ADDENDUM NO. 2

TO THE
BIDDING DOCUMENTS
FOR
KIRKWOOD STREETSCAPE PHASE III
COLLEGE AVENUE TO ROGERS STREET
FOR THE
CITY OF BLOOMINGTON
DEPARTMENT OF PUBLIC WORKS
BLOOMINGTON INDIANA

DATE: February 17, 2010

Drawing No. P4

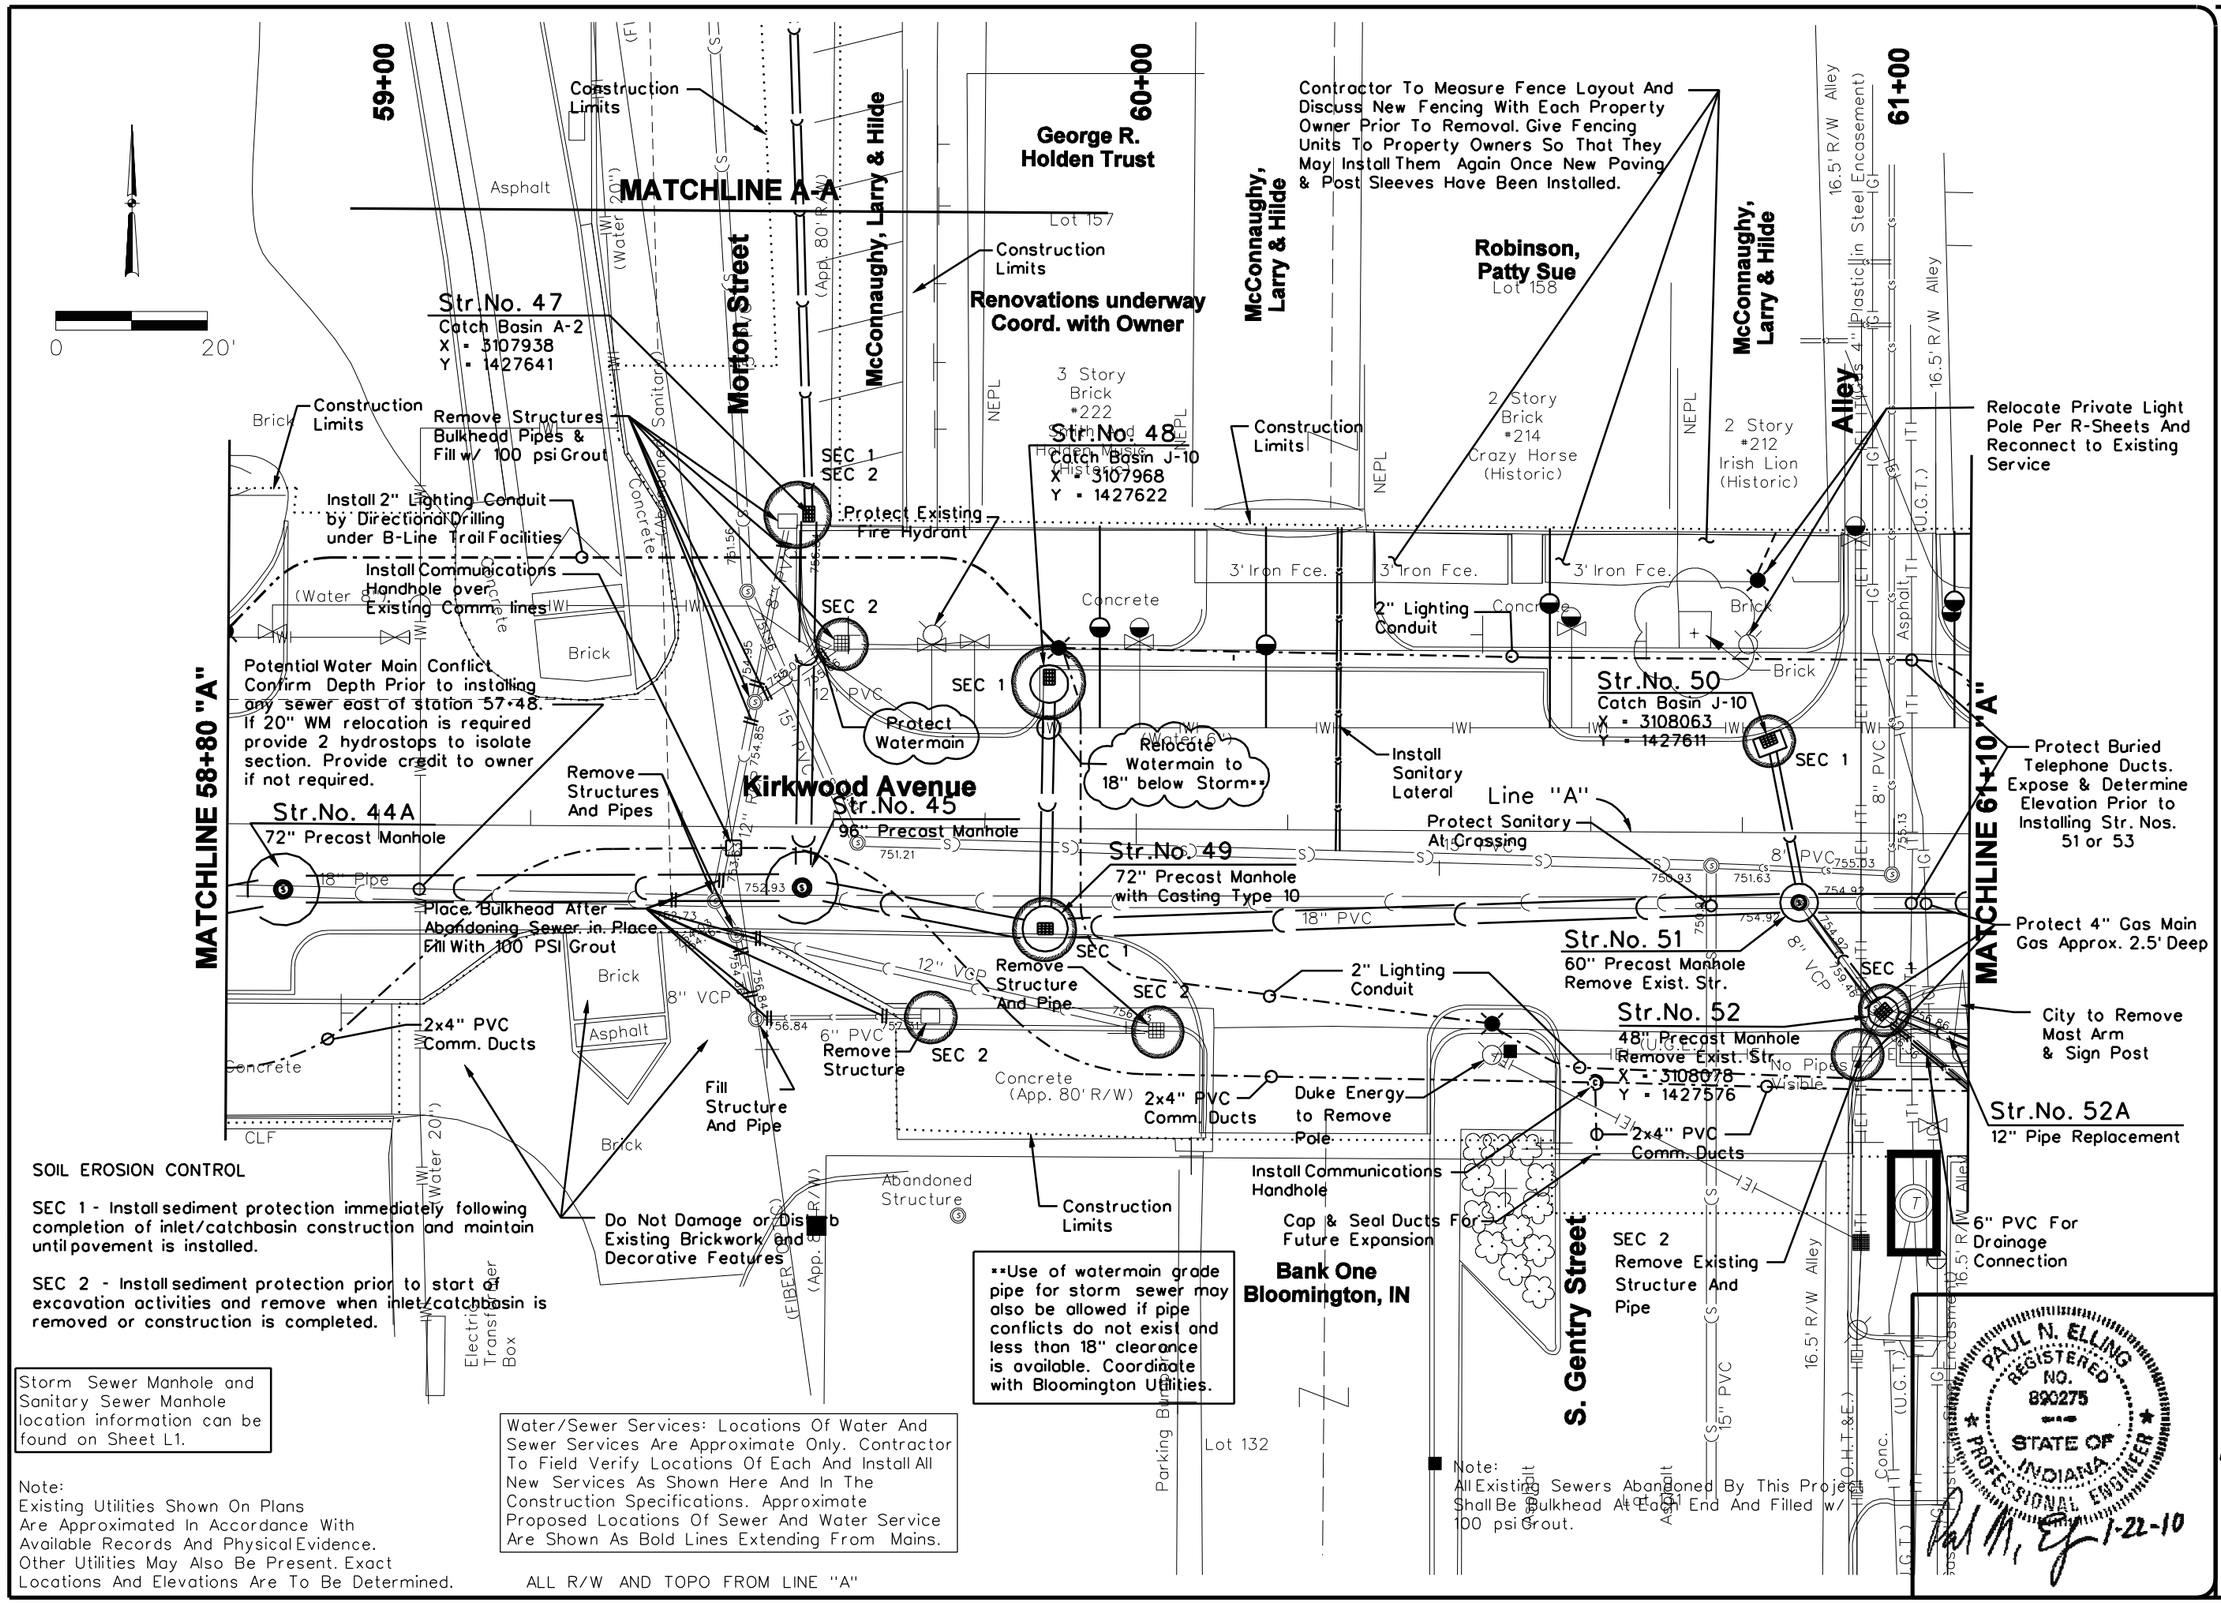
D. The revisions to Sheet 7 Drawing P4 pertain to:

1. Adding direction to the Contractor regarding the relocation of the 20” water main west of the B-Line Trail, and requiring the installation of 2 hydrostops to isolate the section to be relocated. If one or both hydrostops are not needed due to the ability to isolate the section with existing valves a credit is due to the Owner.

2. The City has been advised that demolition and renovation activities on lot 157 (222 West Kirkwood, Holden Music Store) are planned during the period when construction is planned. Contractor shall discuss, coordinate, and schedule his work with the property owner and City of Bloomington to minimize potential impacts and rework.

3. Relocation of the existing water main to be 18” under the proposed storm sewer from structure 48 may not be required if the storm and water pipes do not conflict and the storm sewer is constructed of watermain grade pipe between structure 48 and 49. Confirm if clearance exists and coordinate with City of Bloomington Utilities if use of water main grade piping is desired.

**Use of watermain grade pipe for storm sewer may also be allowed if pipe conflicts do not exist and less than 18" clearance is available. Coordinate with Bloomington Utilities.

Drawing No. P5

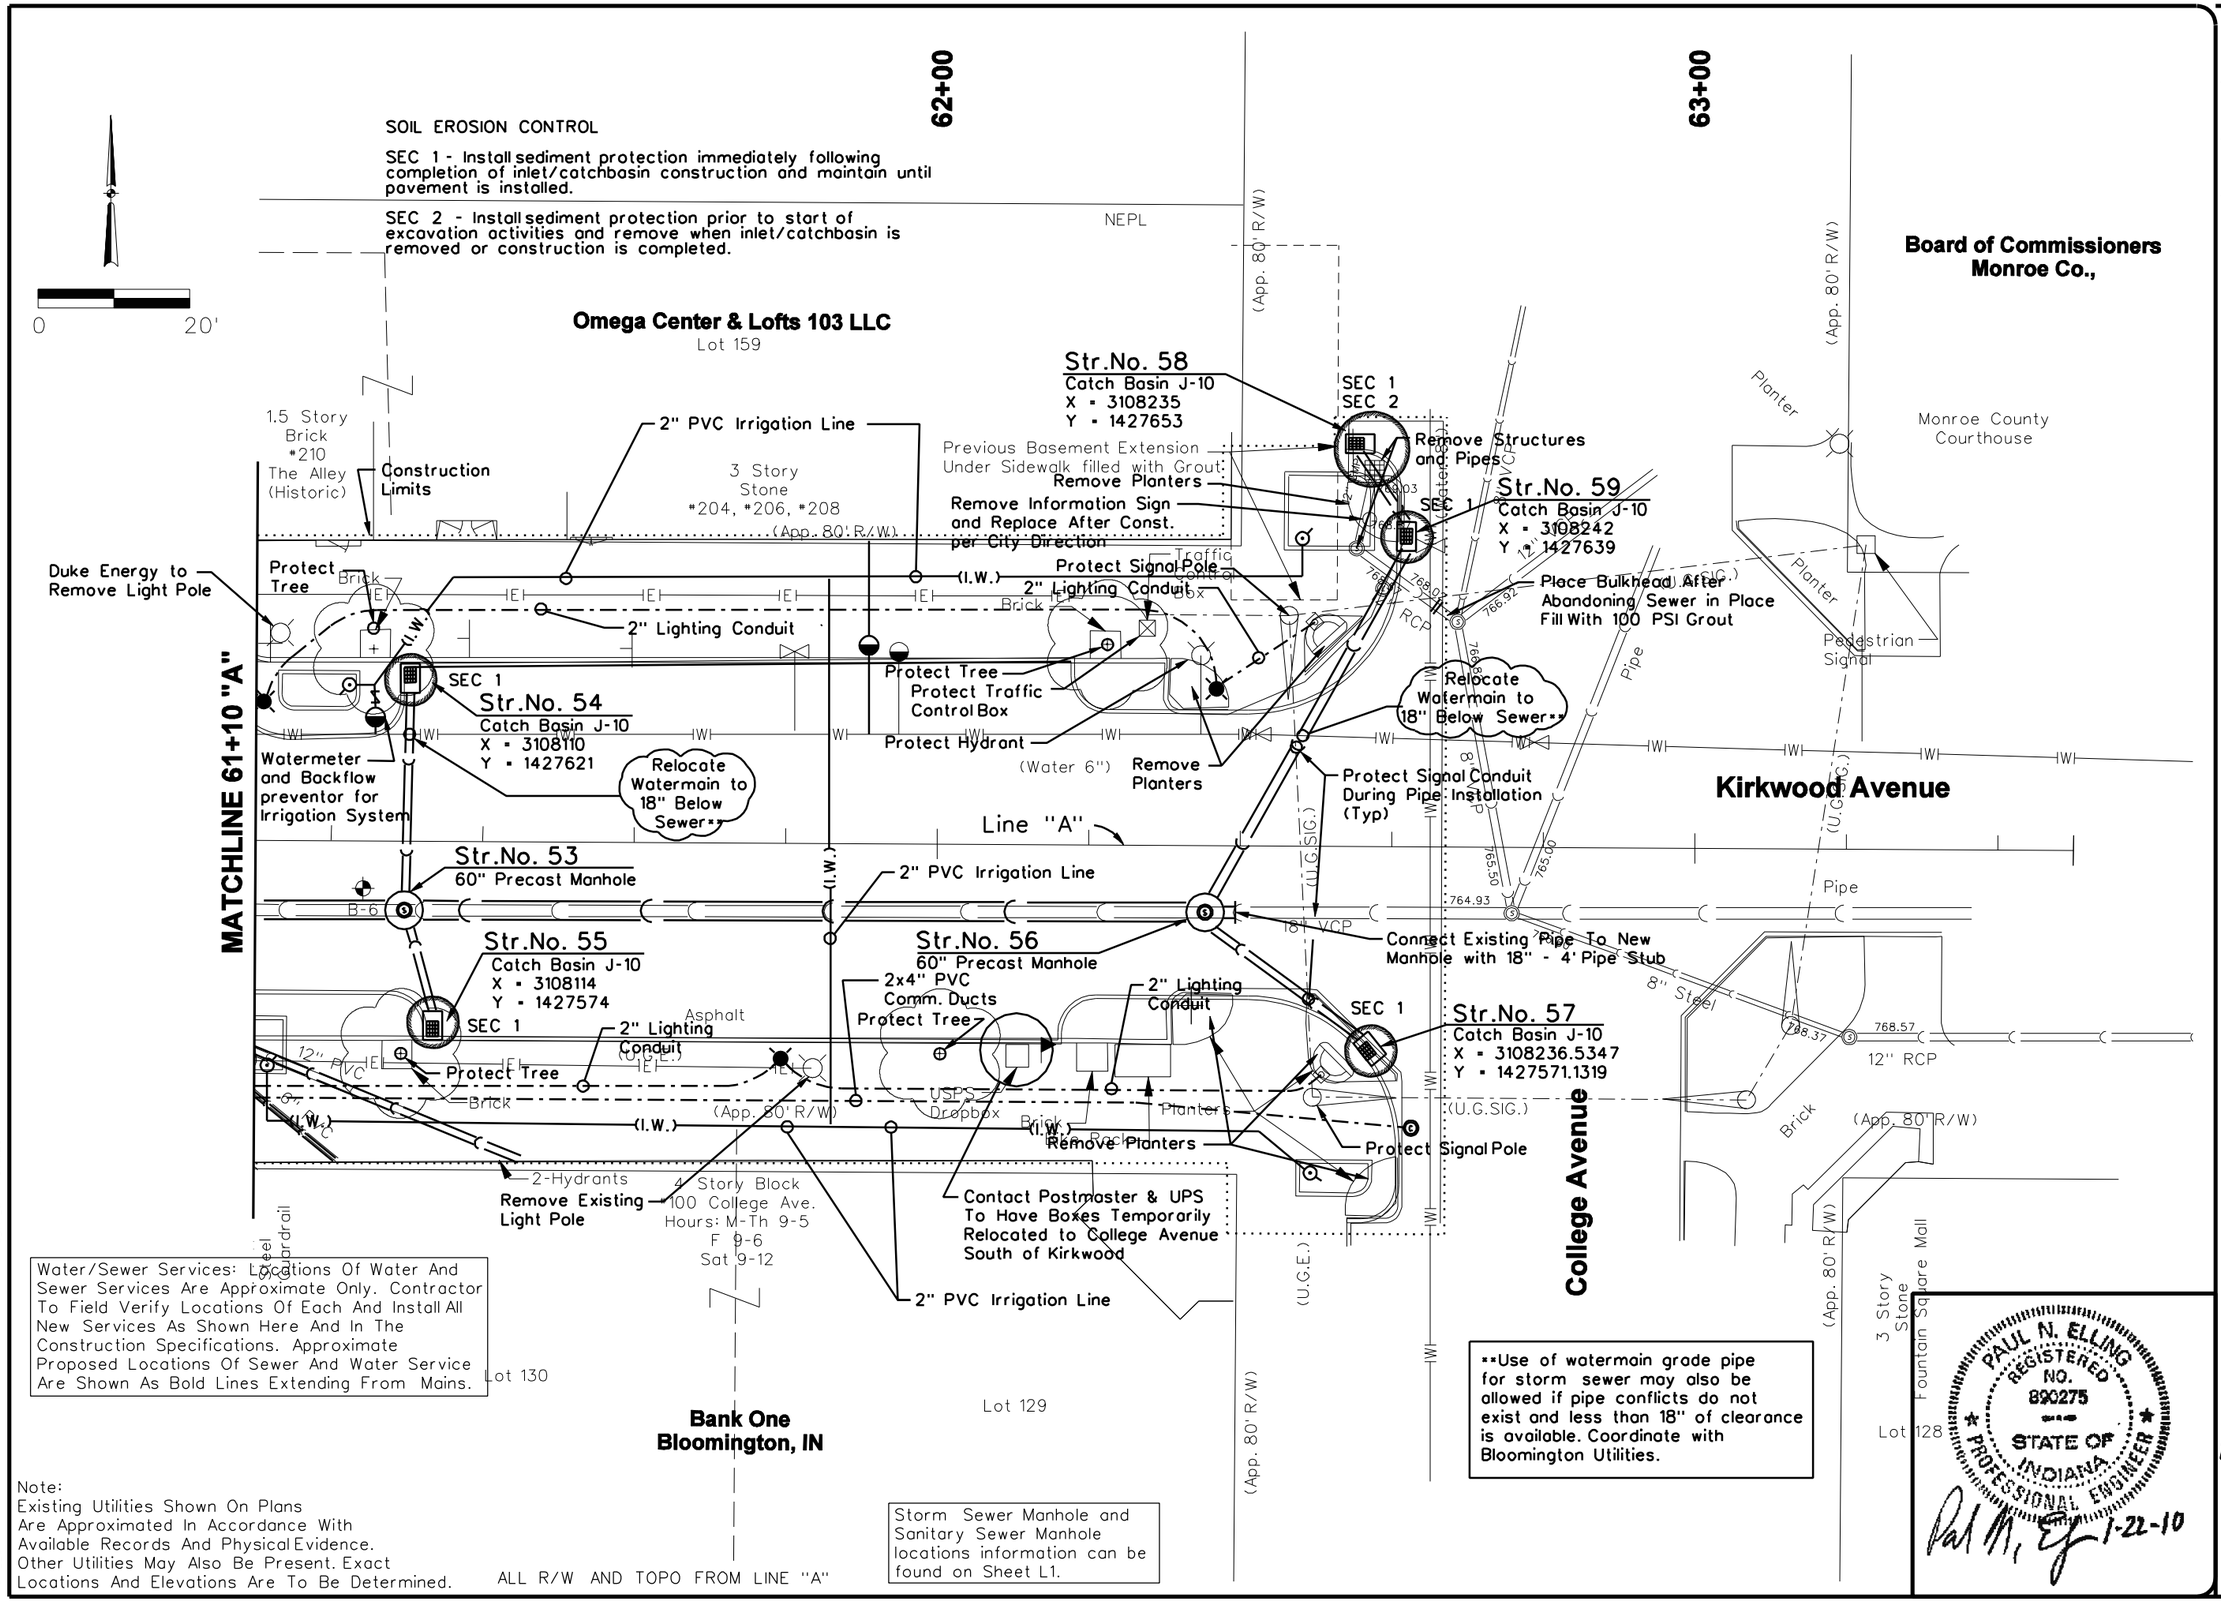
E. The revisions to Sheet 8 Drawing P5 pertain to:

1. Minor revisions to the locations of the irrigation quickconnects in the planters and the location of the water meter pit and backflow preventer.

2. Relocation of the existing water main to be 18” under the proposed storm sewer from structures 54 and 59 may not be required if the storm and water pipes do not conflict and the storm sewer is constructed of watermain grade pipe between structure 54 and 53, and 59 and 56. Confirm if clearance exists and coordinate with City of Bloomington Utilities if use of water main grade piping is desired.

Drawing No. M3

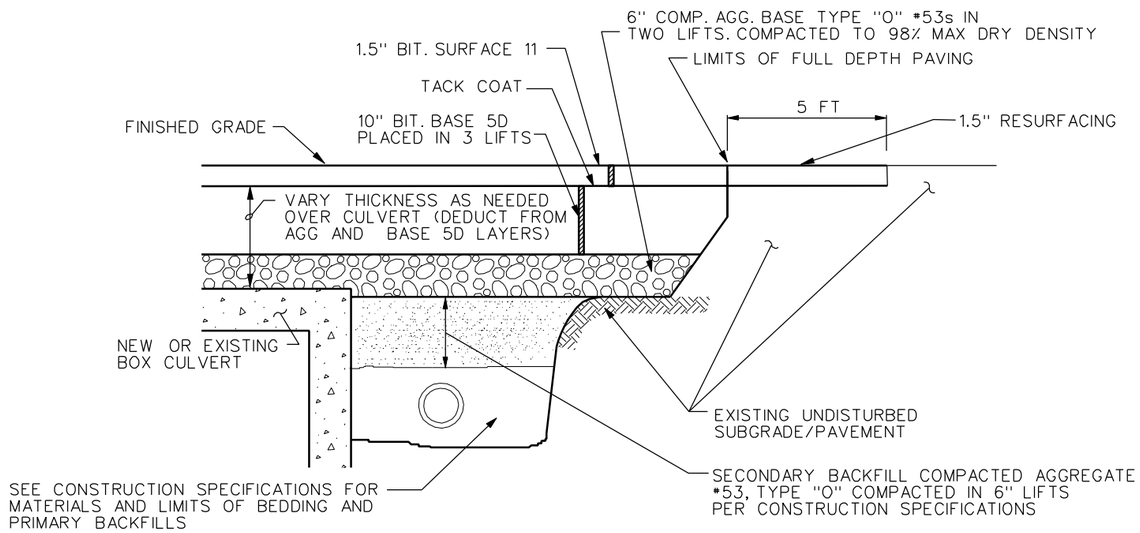
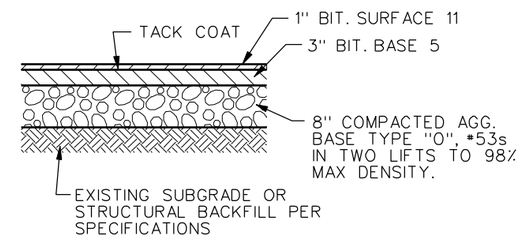
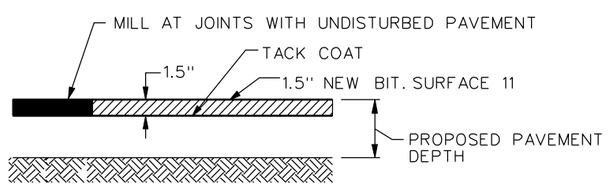
6. Delete Sheet 31 Drawing M3 and replace it with Sheet 31, Drawing M3 attached to this Addenda.

A. Details for Final Street Surfacing and Asphalt Pavement Reconstruction were revised.
